Interactive comment on "A novel model for simulation of nitrate in aquifers" *by* Roohollah Noori et al.

Response to Reviewer' Comments on: https://doi.org/10.5194/hess-2018-222

Response to Comments of Reviewer #1

Figure 3

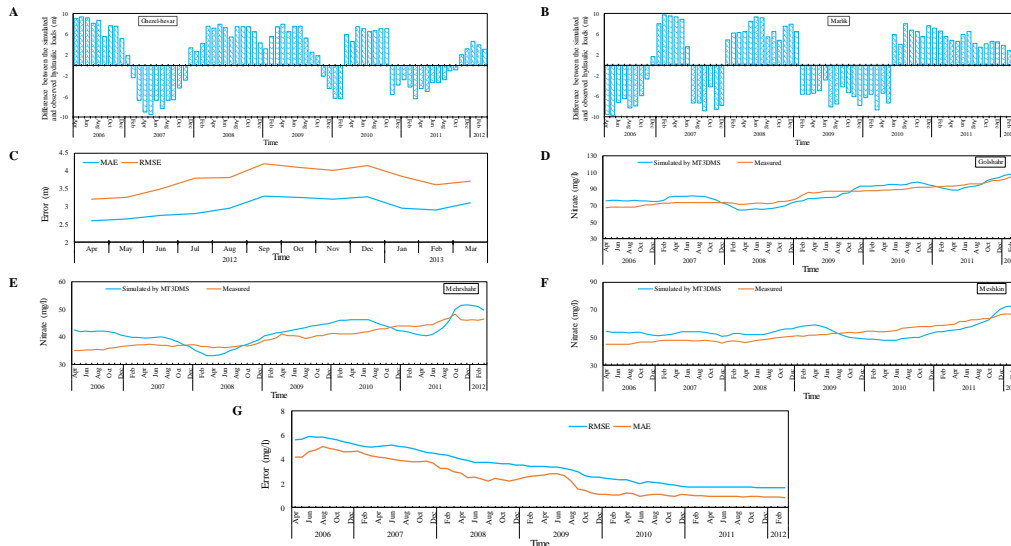
Comment: Page 8, line 5: looking at only the difference can be misleading. Examining timeseries is also important to assess trends. Response: We agree and have now added the trends of measured nitrate concentrations and simulated ones by MT3DMS model. We have also added another figure that properly shows the trends of RMSE and MAE averaged over the study area during the calibration period {Please See Supplement File, Track Change Version (Page 8: Lines 17 – 22; Figure 3D to 3G)}.
